**CITY OF DELAWARE
PLANNING COMMISSION
AGENDA**

PLANNING COMMISSION/STAFF REPORT

CASE NUMBER: 2016-1352

PROJECT: Certified Oil

C4.0 LANDSCAPE PLAN
SCALE: 1"=30'-0"

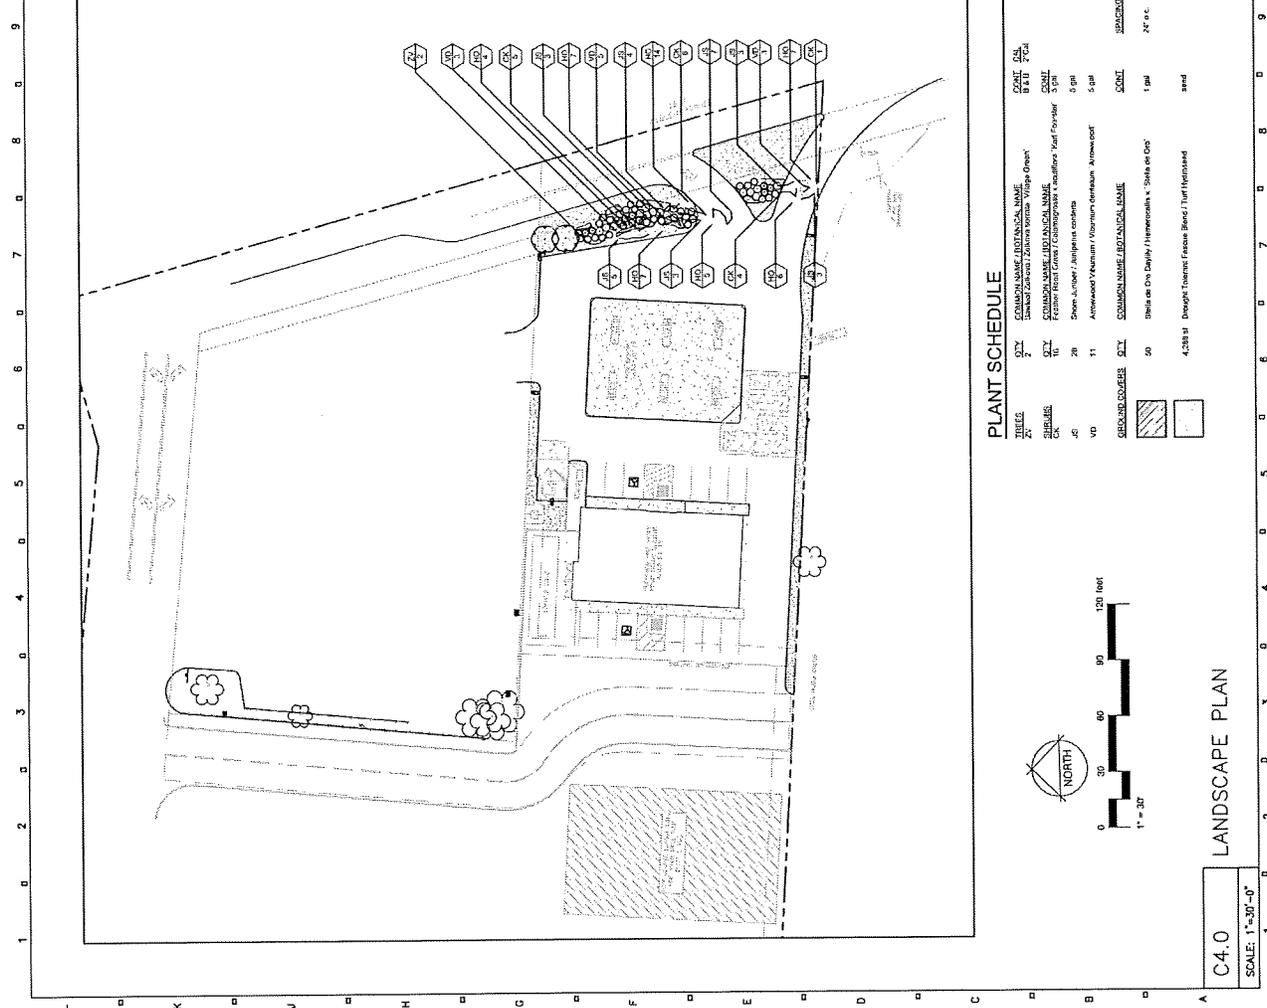
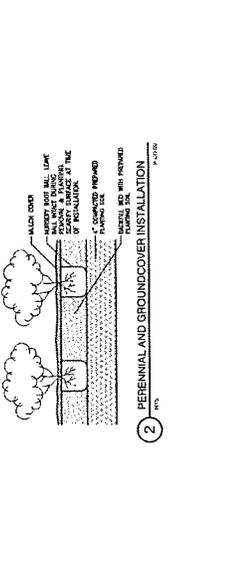
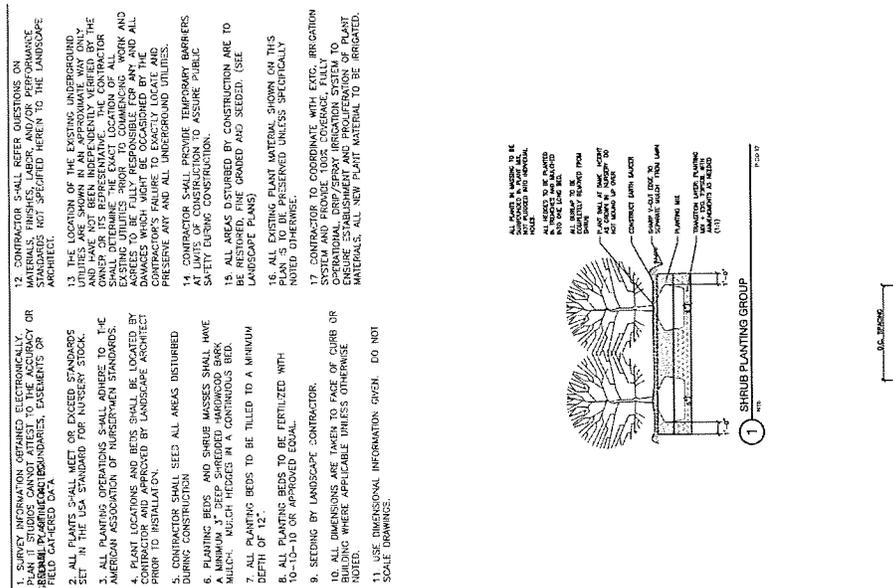
- **LANDSCAPING & SCREENING:** The development would require street and parking lot landscaping. The approximately 150 feet of frontage requires 4 street trees and 3 front yard trees along US 23 North while the owner is proposing two trees. The required additional five trees shall be installed on the site. The US 23 North frontage does not have enough street and front yard trees but the limited site and access requirements make it impossible to install all the trees along the frontage. The required landscaping should be installed along the

north and south boundaries of the site. The Shade Tree Commission would have to review and approve all landscape plans.

6. The Shade Tree Commission shall review and approve the submitted street tree plans.
7. Any qualifying removed trees shall achieve compliance with Chapter 1168 Tree Preservation Requirements.

EXTERIOR ELEVATIONS

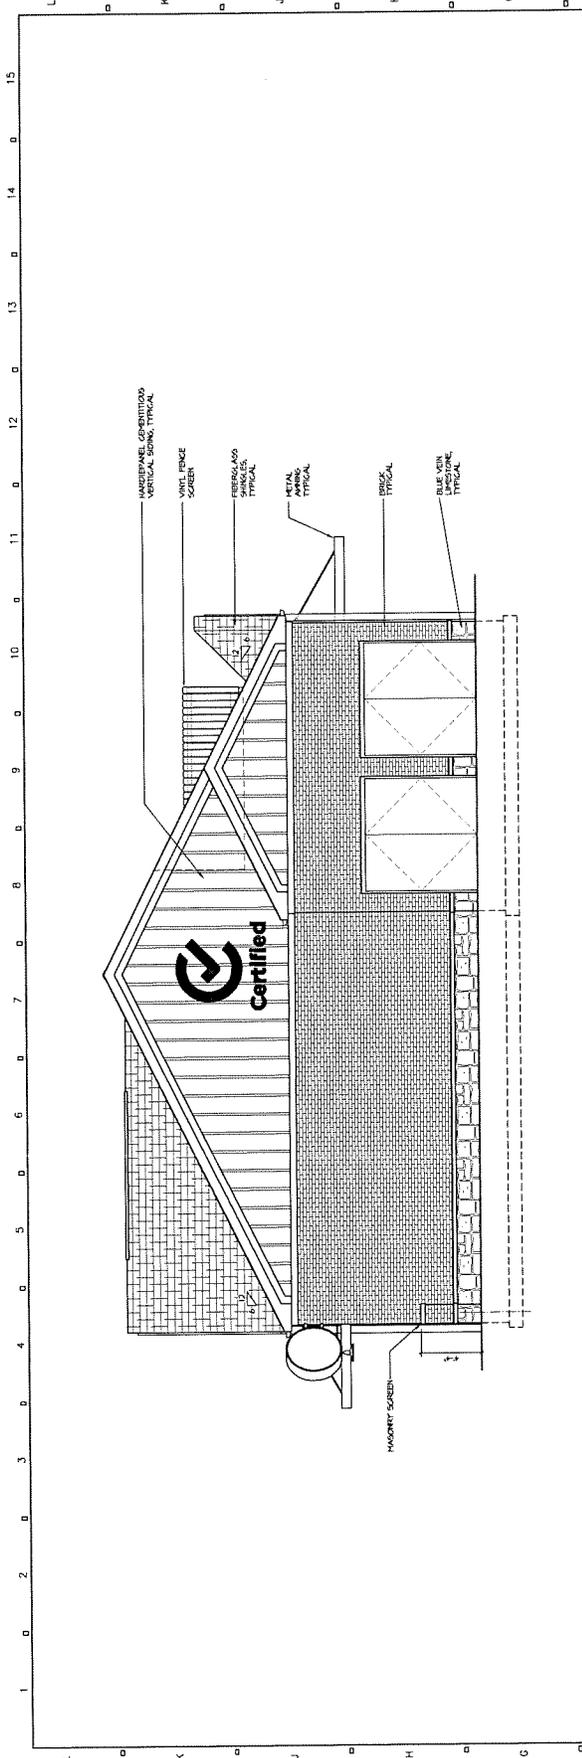
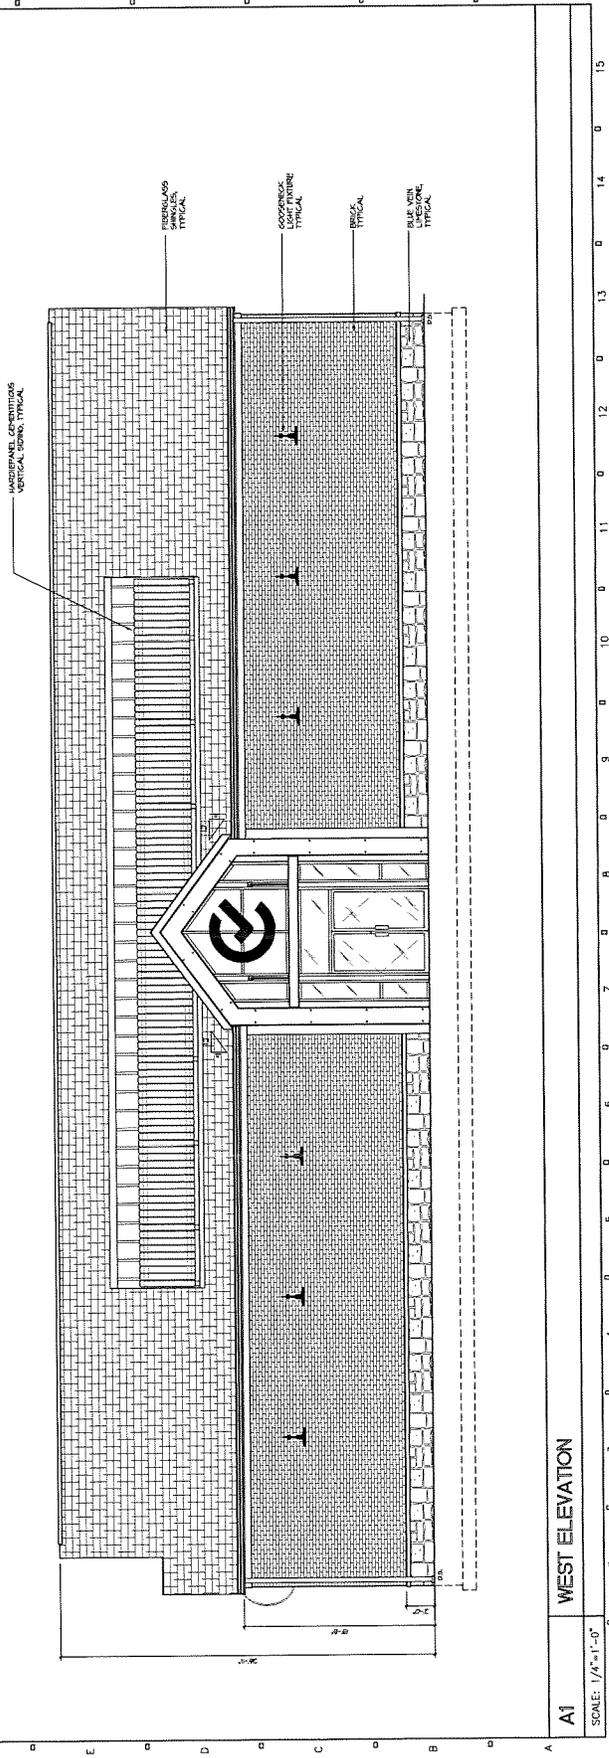
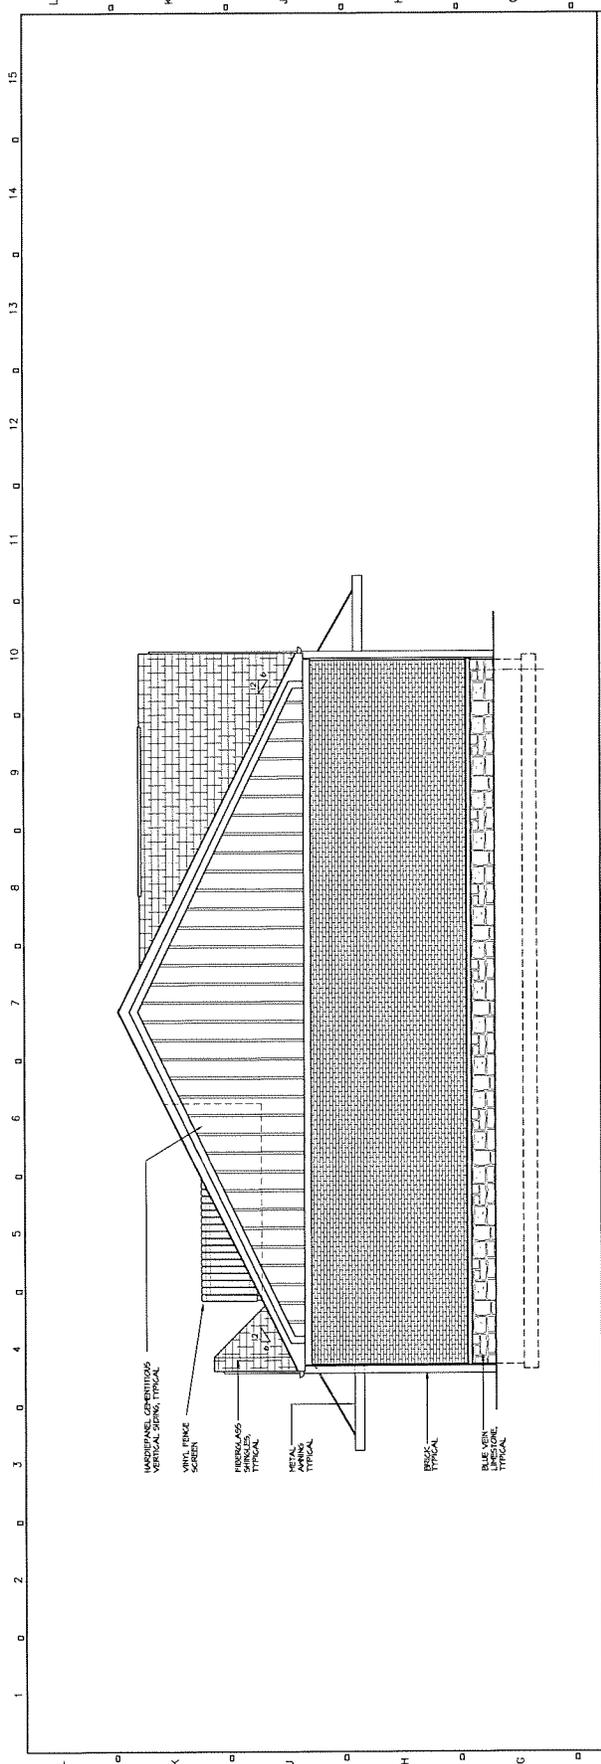
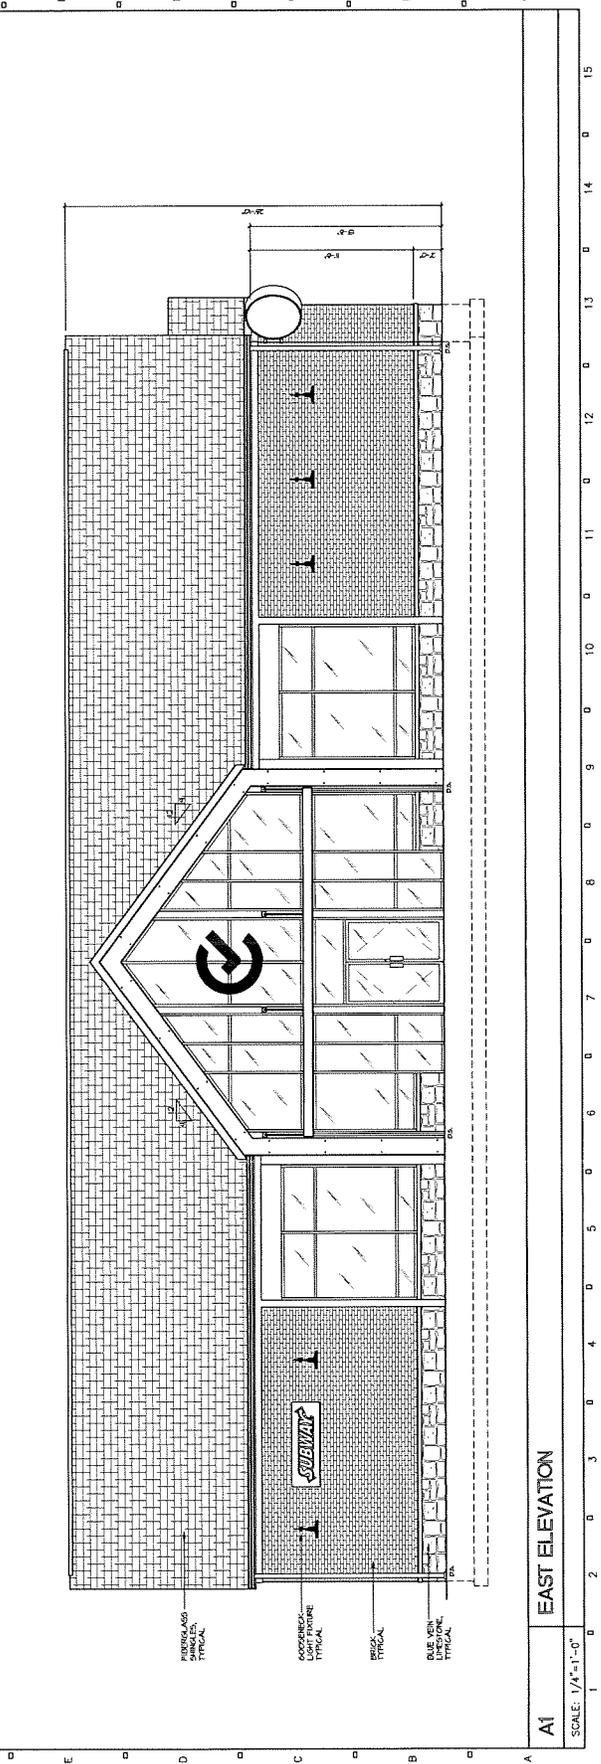
- **SIGNAGE:** The owner is proposing building, fuel canopy and ground signage. The proposed signage on the east elevation contains the Certified logo (approximately 20 square feet) and Subway sign (approximately 5 square feet) south of the main entrance between two gooseneck lights. If internally illuminated, the Subway sign shall be channel letters to achieve compliance with the zoning code. Seasonal or sale signage should be contained inside the front windows and should be designated on the plan to allow for future enforcement. Also, they are proposing a projection sign on the northern portion of the east elevation which is prohibited. On the west and north elevations a Certified logo (approximately 20 square feet) is proposed. The sign on the north elevation is not permitted per code because it does not front a street or parking lot. The vehicular fuel canopy sign on the north, south and east elevation (front) would encompass a maximum 22 square feet regardless if it is Sunoco or Marathon and would be required to be channel letters flush mounted on the canopy. The canopy signs shall be flush mounted (or inset to achieve a flush mounted appearance) such that the sign faces do not extend past the front face of the canopy. Staff recommends the entire band behind the signage be beige to match the rest of the canopy and not Sunoco blue or Marathon white. The proposed ground sign would be located just north of the curb cut on US 23 North and would be 8 feet high (40 square feet) mounted on a 3 foot high limestone base. The sign would have two digital pricers along with three panel signs which would achieve compliance with the adopted City Gateway and Corridor Plan as well as the sign code. The sign shall be flush mounted to the stone base.

16. The projecting sign on the east elevation and the wall sign on the north elevation shall not be permitted per code.
17. The outdoor merchandise (ice box, propane tanks, etc.) shall be located on the north side of the building with installation of a low wall (2 to 3 feet tall) to delineate the storage area and shield the "outside merchandise" from public right-of-way. No movie boxes, ATM machines, etc., shall be allowed outside the building.

18. Brick insets or rectangular color variations shall be designed on the building elevations to break up the blank wall space. These shall be submitted, reviewed and approved by Staff.
